**PLANNED UNIT DEVELOPMENT &
PLANNING APPROVAL STAFF REPORT****Date: June 1, 2006****NAME**

Mike & Daphne Sullivan and Delmas & Sue Whatley

LOCATION4161 Dauphin Island Parkway
(East side of Dauphin Island Parkway, 190'± North of Terrell Road).**CITY COUNCIL
DISTRICT**

Planning Approval to allow a recreational vehicle park in a B-3, Community Business district, and Planned Unit Development Approval to allow multiple buildings on a single building site.

SITE PLAN

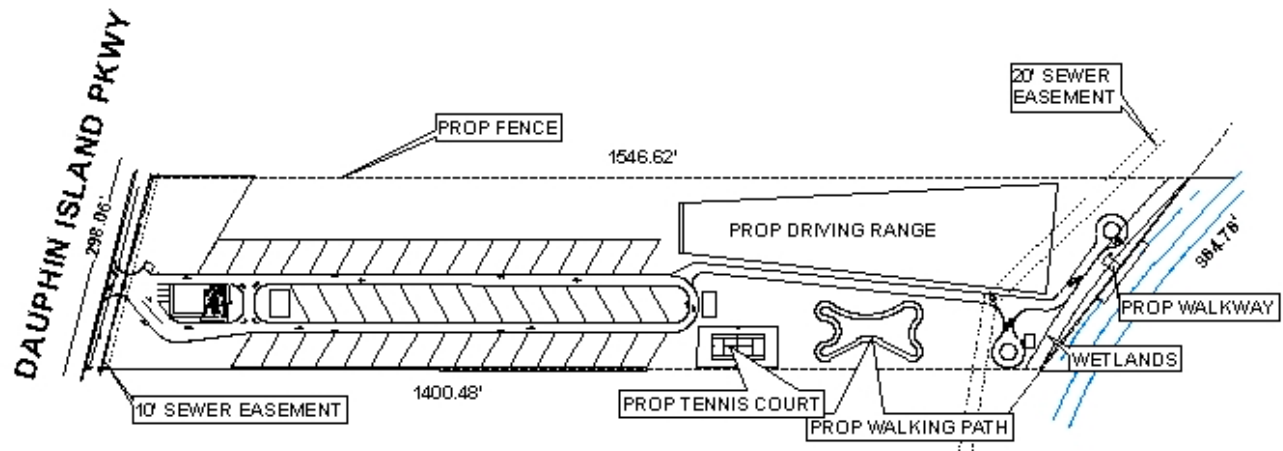
The proposed one-way circulation system, with a pavement width of 15-feet, seems inadequate for the movements that will be required for the larger RVs to turn or back-into proposed parking spaces. It would also appear that the turning radius may not be adequate to assure that the larger RVs will not cut the corners when making the turn to return to the front of the property. The circulation system also does not appear to be designed to allow a large RV to circle around the office structure if necessary to return into the RV parking area. Other circulation on the site is not depicted, specifically, how users of the various facilities on the property will get from place to place – no pedestrian paths to the boat house or other facilities are indicated. It is also assumed that the operators of the RV park would periodically need vehicular access to the boat house and pier area, thus some sort of drive or access route should be depicted on the site plan.

The site abuts existing residences to the South. Because the site is zoned commercially and abuts residential uses, a protection buffer in conformance with Section 64-4.D. is required. The required protection buffer may be a 10-foot wide planting strip or a six (6) feet high privacy fence (except for the portion of the fence within the 25-foot setback line, which can only be 3-feet tall). The site plan should be revised to depict the required protection buffer.

It is anticipated that lighting will be provided on the site. Any lighting provided must comply with Section 64-4.A.2. of the Zoning Ordinance, and not shine directly into adjacent residential areas or into traffic. The site plan should be revised to depict any exterior lighting, and information provided to staff regarding selected lighting fixtures in order to ensure conformance with the lighting requirements of the Zoning Ordinance.

The unpaved RV parking is of concern as Section 64-6.3.a. of the Zoning Ordinance, with few exceptions, requires paved parking areas. While use of gravel at a campsite may be compatible with the natural surroundings, the fact that modern RVs (Class A motorhomes) can exceed 30,000 pounds (15 tons) gross vehicular weight is of concern as it relates to the longevity and appropriateness of gravel parking areas. Furthermore, any other “by-right” uses allowed within a B-3 district would be required to provide paved parking. Therefore, it is recommended that all RV parking areas be paved, in conformance with the Zoning Ordinance.

There is no indication on the site plan as to the proposed location of any dumpster or other waste storage facility. If the applicant utilizes a dumpster, the location of the storage area for the dumpster must be indicated on the site plan, and the location and required screening must comply Section IV.D.9. of the Zoning Ordinance, as well as with all other applicable regulations.

Buffering of the site from adjacent residential uses has been depicted on the site plan, and includes a 6-foot privacy fence, and a 4-foot wide landscape strip. Due to the size of the site and approximately 100 feet of property available North of the proposed RV parking area, the area that will be developed for RV parking should be moved North, away from the residences along the Southern property boundary in order to minimize noise, visual and lighting conflicts. Unless there are constraints on the site, the entire RV parking area should be moved North 50 feet.

The proposed dumpster with the required screening is shown on the revised site plan. It appears that it is within the required front yard setback, which is prohibited by Section IV.D.9. of the Zoning Ordinance. Therefore, the dumpster location should be moved so that it will be in full compliance with the requirements.

Proposed lighting is depicted on the revised site plan, and generally appears to be located so as to minimize overflow onto adjacent residential uses. Lighting for the proposed tennis courts should be designed to ensure that lighting is confined to the site.

The City of Mobile will require an access agreement from the property owner for placement of the proposed pier / walkway across the City's drainage easement along Perch Creek. Furthermore, wetlands must be depicted on the site plan, and approvals will be required from the U.S. Army Corps of Engineers regarding work on the site due to wetlands before any building permits can be obtained or land disturbance activities undertaken.

RECOMMENDATION: **Planning Approval:** *Based upon the preceding, this request is recommended for Approval, subject to the following conditions: 1) revision of the site plan to depict the RV parking area 50 feet North of the location depicted on the revised site plan; 2) relocation of the proposed dumpster so that it fully complies with Section IV.D.9. of the Zoning Ordinance; 3) approval of all applicable federal, state and local agencies prior to the issuance of any permits or land disturbance activities; 4) placement of a note on the site plan stating that the site is limited to one curb-cut, with the size, design and location to be approved by Traffic Engineering and ALDOT, and conform to AASHTO standards; 5) full compliance with the tree and landscaping requirements of the Zoning Ordinance; 6) provision of a 6-foot high privacy fence along the South boundary of the property, except for that portion within 25-feet of the right-of-way of Dauphin Island Parkway; 7) full compliance with all other municipal codes and ordinances; and 8) submission and approval of the revised site plan to Urban Development – Planning Section, prior to submission for building or land disturbance permits.*
